ADDENDUM NO. 1

Date: December 23, 2022

Issued by: Tracy Joint Unified School District

Project: **Project #2022/23-002 Tracy High Tennis Court Repairs**

Additive Group Production BMD

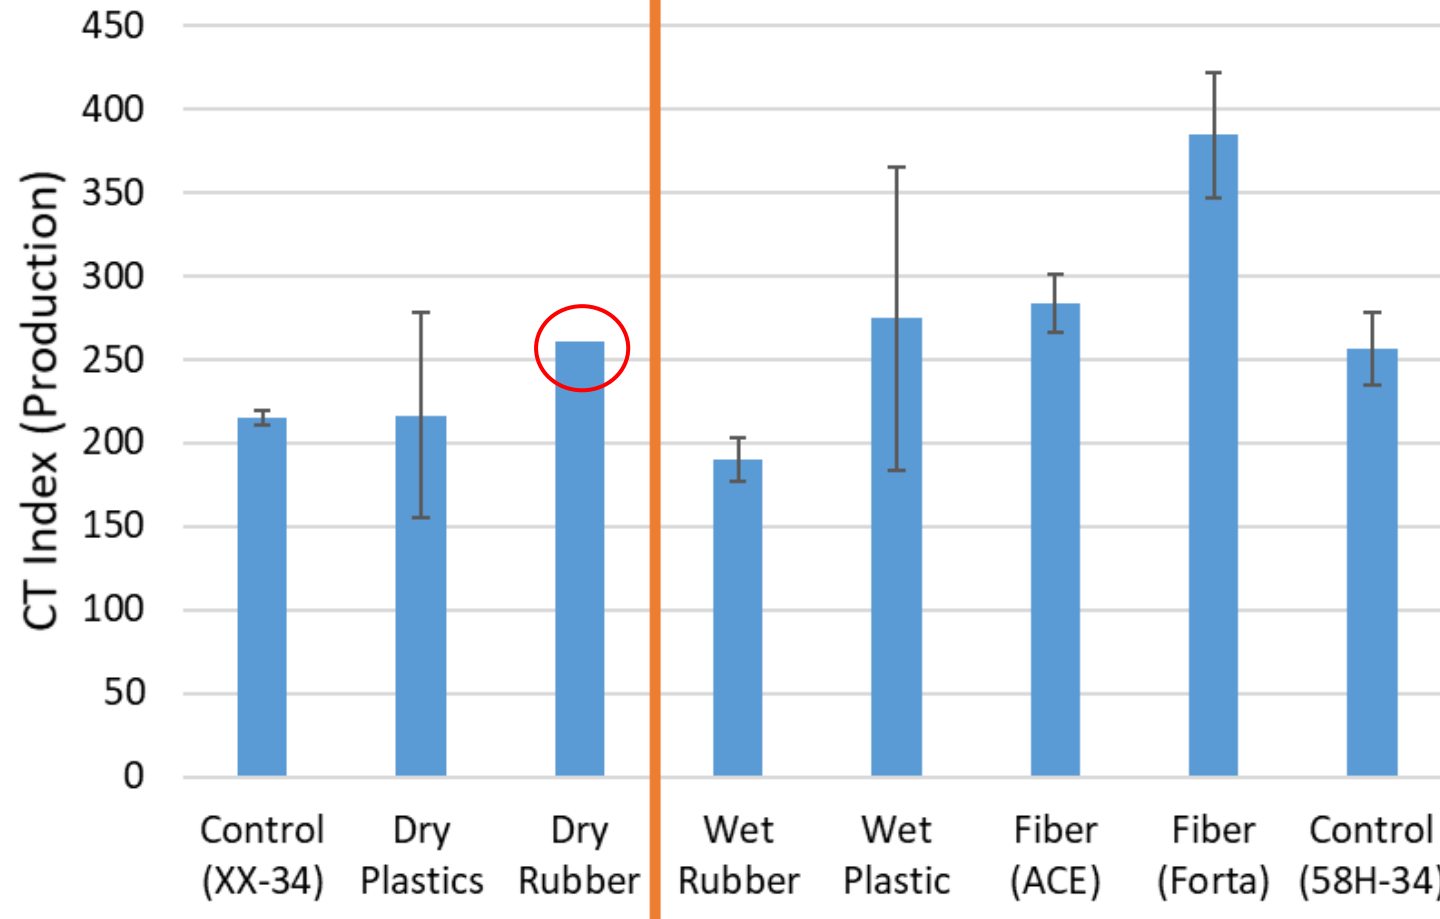
Recent testing performed by NCAT and MnROAD showed a significant difference (~20%) in cracking tolerance performance (Ideal-CT) in a study of the ACE fiber compared to the Forta-Fi Fiber. This was a study performed on actual production mixes, not lab mixes. At this time, the ACE fiber is not considered an acceptable alternative and is not viewed as a superior product for this reason. Documentation from those studies is provided for reference as part of this document.
